XC2080ED, XC2090ED

16/32-Bit Single-Chip Microcontroller
with 32-Bit Performance
XC2000 Family / High Line

Errata Sheet

V1.6 2013-03

Figure 1 Critical application reset sequence

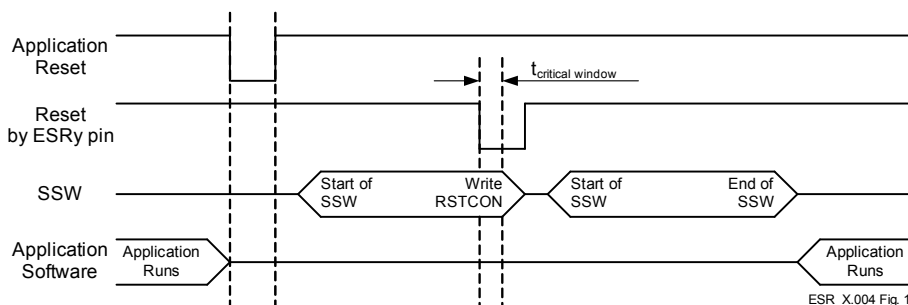
SCU_RSTCONx registers are reset only by Power-On, but they may be wrongly affected after a second application reset requested by an ESRy pin. This may lead to the SCU_RSTCONx register values being set to zero, which could unexpectedly disable reset sources within the user application. The conditions which lead to this behavior are:

1. First, an application reset by SW (software), CPU (Central Processing Unit), MP (Memory), WDT (Watchdog Timer) or ESRy (External Service Request y) occurs.
2. Following this, an application reset on an ESRy pin occurs.
3. If the above mentioned ESRy reset occurs during a critical time window of the SSW (startup software), then it's possible that the application will operate with the wrong SCU_RSTCONx register value. The critical time window occurs when the SSW is writing the SCU_RSTCONx registers, and at the same time, the ESRy reset request is processed by the reset circuitry. The width of this critical window $t_{\text{critical window}}$ is less than 13 cycles.

- Initialize SCU_RSTCONx registers by user software after any reset, or
- assure that a second application reset request with an ESR pin does not occur during the critical time window.

Figure 2 Example for a Slow Input Signal

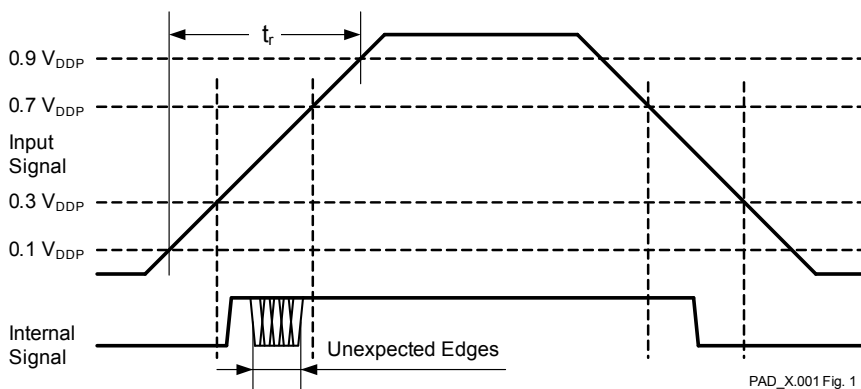
The digital input- and I/O-pins are designed using Schmitt trigger input structures with hysteresis. Even with this structure, it is possible that very slow rising edges may generate spikes, resulting in unexpected additional edges at the input signal.

The next picture **Figure 2** is an example for a slow input signal, with spikes shown on the slow rising input signal.

The first rising edge in [Figure 2](#) of the internal signal is always valid. The edges which are marked with “Unexpected Edges” must be ignored.

Figure 4 Rising Edge Detection Approach

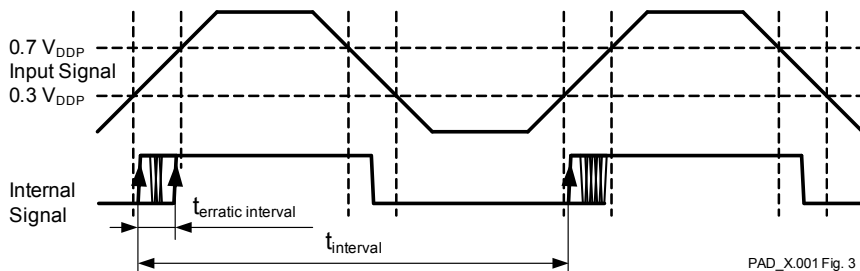
In case of rising edge detection multiple interrupts would be generated when the spike occurs. The time interval since the last interrupt can be measured – if it is very small compared to the expected value, this would indicate a spike and the interrupt should be ignored.

If the time between the rising signal edge and the rising edge caused by a spike $t_{erratic}$ is less than the ISR service time, a workaround would be to clear the interrupt request (IR) flag before the return from interrupt is done. The clearing of the IR flag will avoid a further erratic interrupt.

Figure 5 Rising Edge and Falling Edge Detection Approach

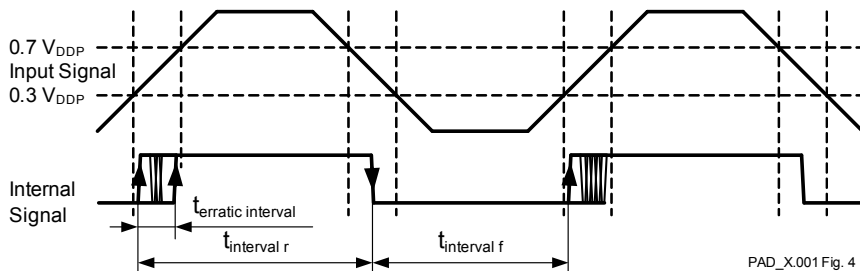
The rising edge detection workaround works also if both edges are used as trigger for interrupt and the following conditions are valid:

- $t_{erratic\ interval} \ll t_{interval\ r}$ and
- $t_{erratic\ interval} \ll t_{interval\ f}$

Figure 6 Alert Interrupt Behavior in case of Bus-Off

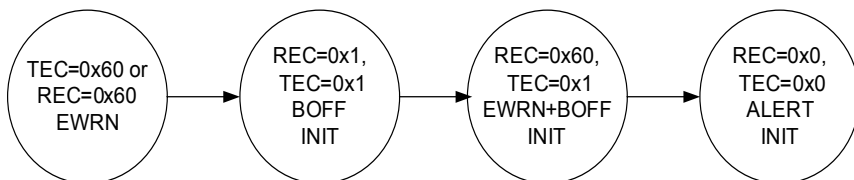
The MultiCAN module shows the following behavior in case of a bus-off status:

When the threshold for error warning (EWRN) is reached (default value of Error Warning Level EWRN = 0x60), then the EWRN interrupt is issued. The bus-off (BOFF) status is reached if TEC > 255 according to CAN specification, changing the MultiCAN module with REC and TEC to the same value 0x1, setting the INIT bit to 1_B, and issuing the BOFF interrupt. The bus-off recovery phase starts automatically. Every time an idle time is seen, REC is incremented. If REC = 0x60, a combined status EWRN+BOFF is reached. The corresponding interrupt can also be seen as a pre-warning interrupt, that the bus-off recovery phase will be finished soon. When the bus-off recovery phase has finished (128 times idle time have been seen on the bus), EWRN and BOFF are cleared, the ALERT interrupt bit is set and the INIT bit is still set.

Figure 7 Loss of Arbitration

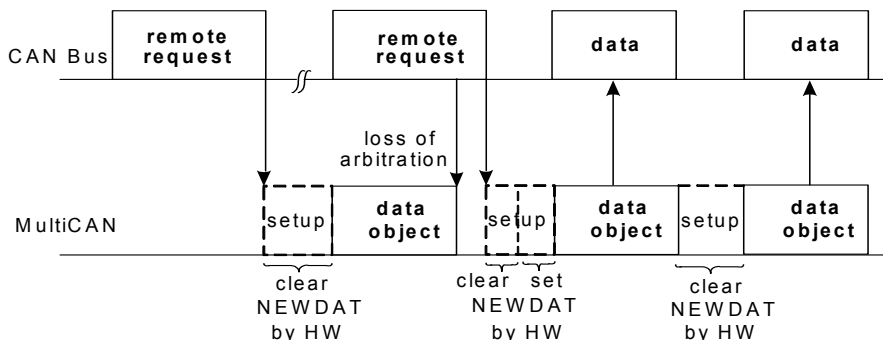
When the appropriate message object (data frame) triggered by the first remote frame wins the arbitration, it will be sent out and `NEWDAT` is not reset. This leads to an additional data frame, that will be sent by this message object (clearing `NEWDAT`).

There will, however, not be more data frames than there are corresponding remote requests.
